**GEOTECHNICAL INVESTIGATION
PROPOSED RESIDENTIAL SUBDIVISION
PART 1, PLAN 5R-10284
2050 DUNROBIN ROAD
WEST CARLETON WARD
CITY OF OTTAWA, ONTARIO**

Issued in support of the Subdivision Agreement
Revision 1 – Issued in Response to City Review Comments

Response to Geotechnical Review Comments

The following geotechnical review comments were received May, 2022. Kollaard Associates Inc.'s response is provided in italics immediately after each comment for clarity:

FOOTING BEDROCK -
OVERBURDEN TRANSITION TREATMENT

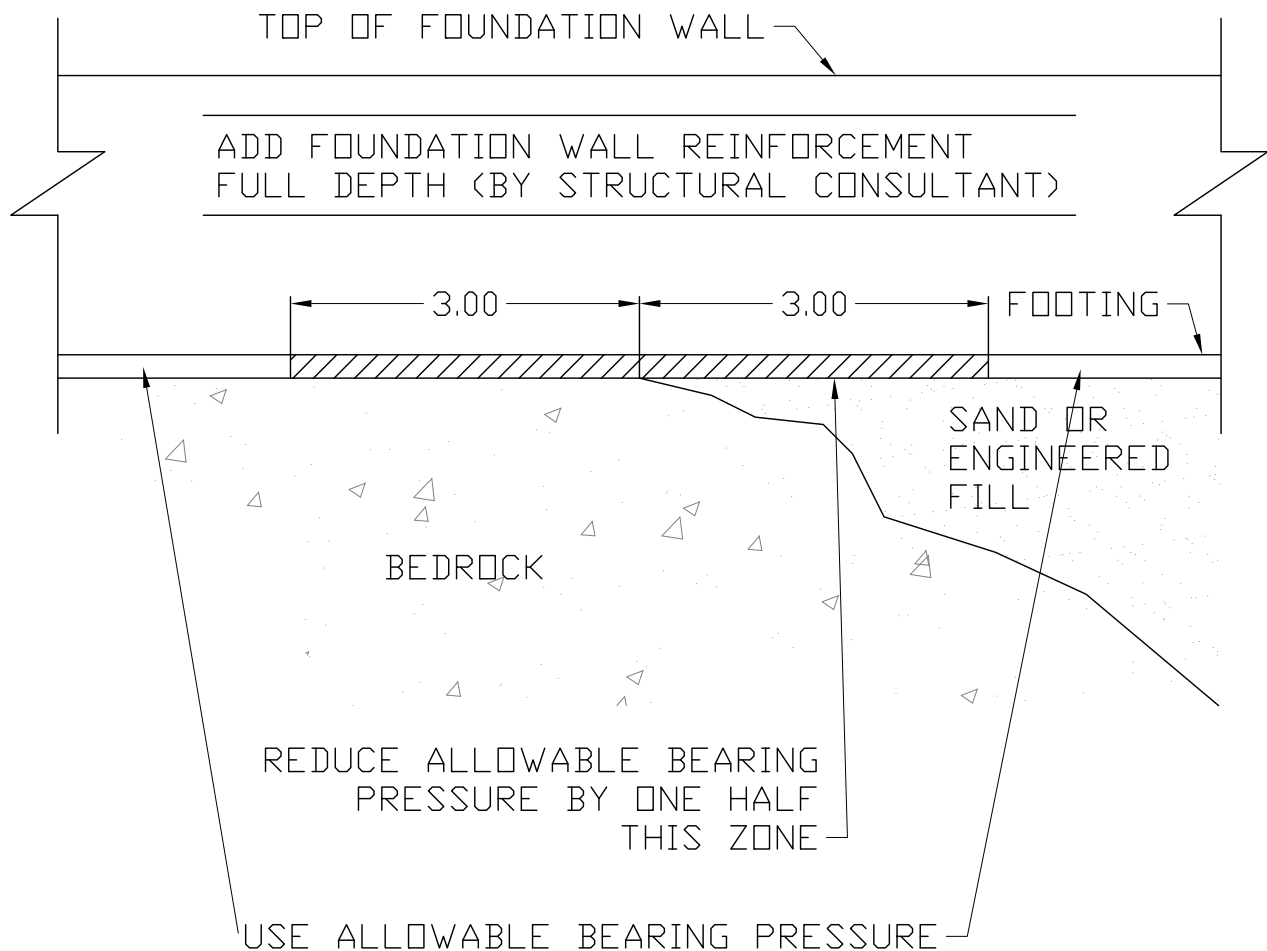
9. Please provide the recommended insulation detail, mentioned in Section 5.2.6 of the report.

To minimize the potential for foundation cracking where footings will be founded on both overburden materials and bedrock, it is suggested that the foundations walls in the transition zone be suitably reinforced. Suggested foundation treatment for overburden/bedrock transition areas are provided in the attached Figure 3.
